CMD 26-M4.7A  
CMD 26-M5.15A  
CMD 26-M6.6A  
CMD 26-M7.6A

**Regulatory Oversight Report for  
Canadian Nuclear Laboratories  
Sites: 2024**

# **Kebaowek First Nation's Presentation to the Canadian Nuclear Safety Commission**

*Comments on the  
2024 Regulatory  
Oversight Reports*

**Table 16**  
Radioactive Solid Waste Shipments to [REDACTED] for 2024

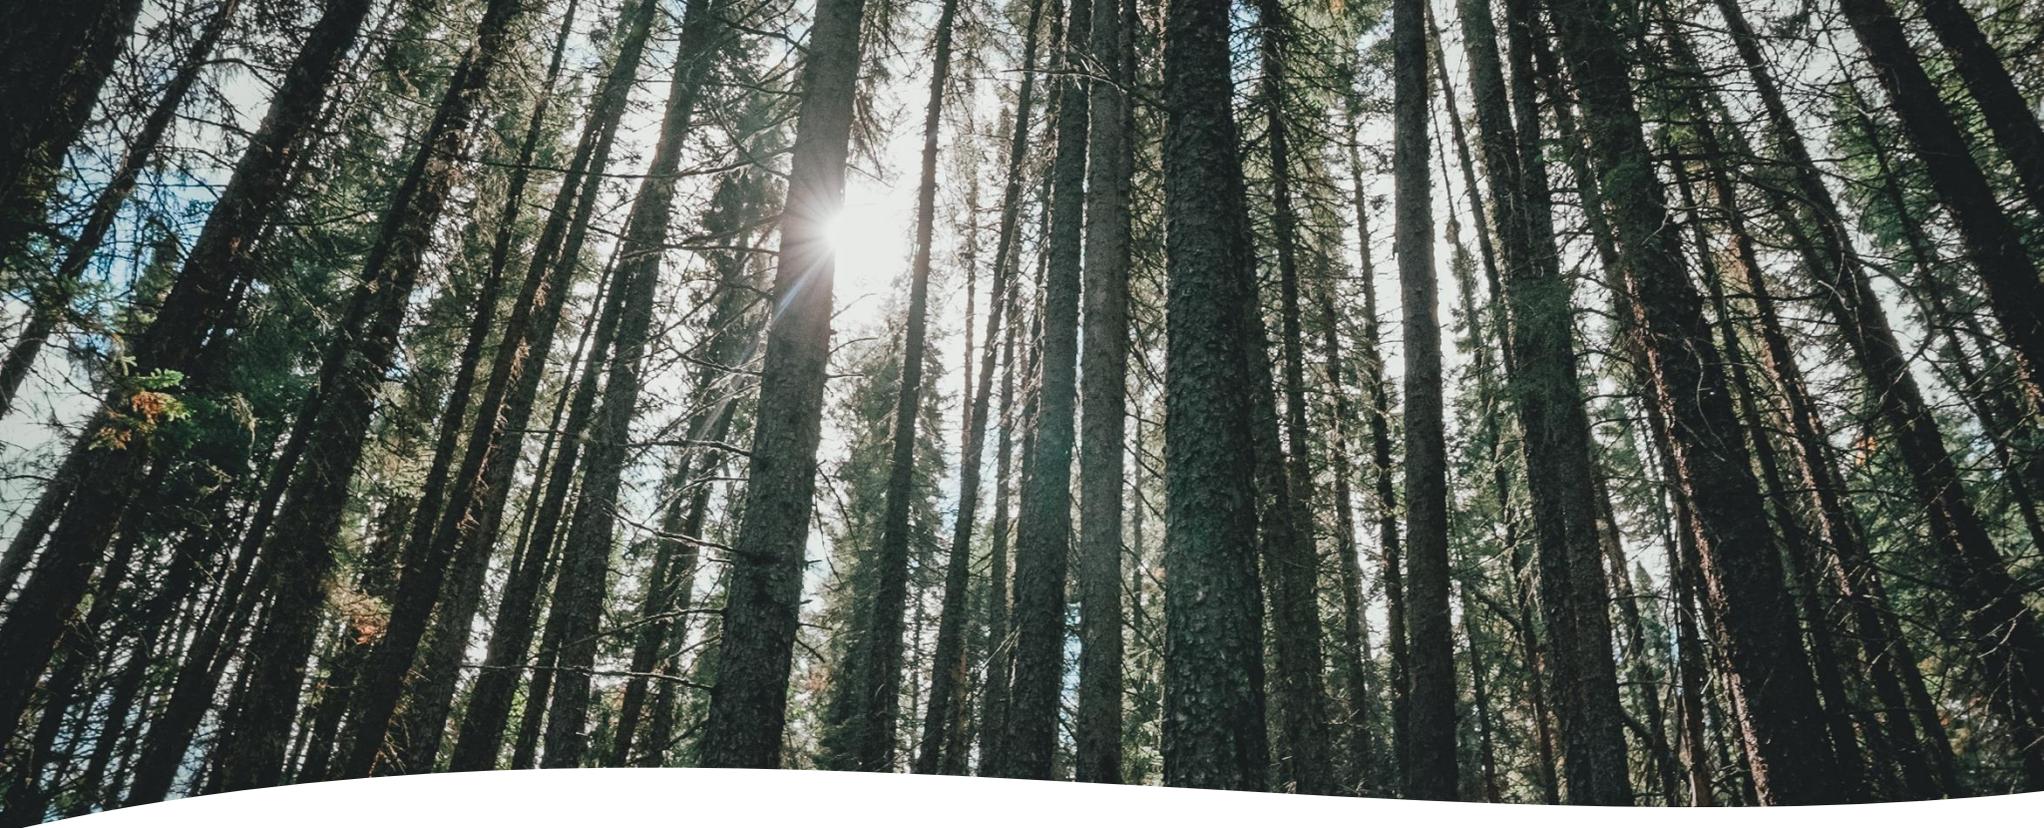
- Limited transparency regarding nuclear waste transfers (see pages 10-12)
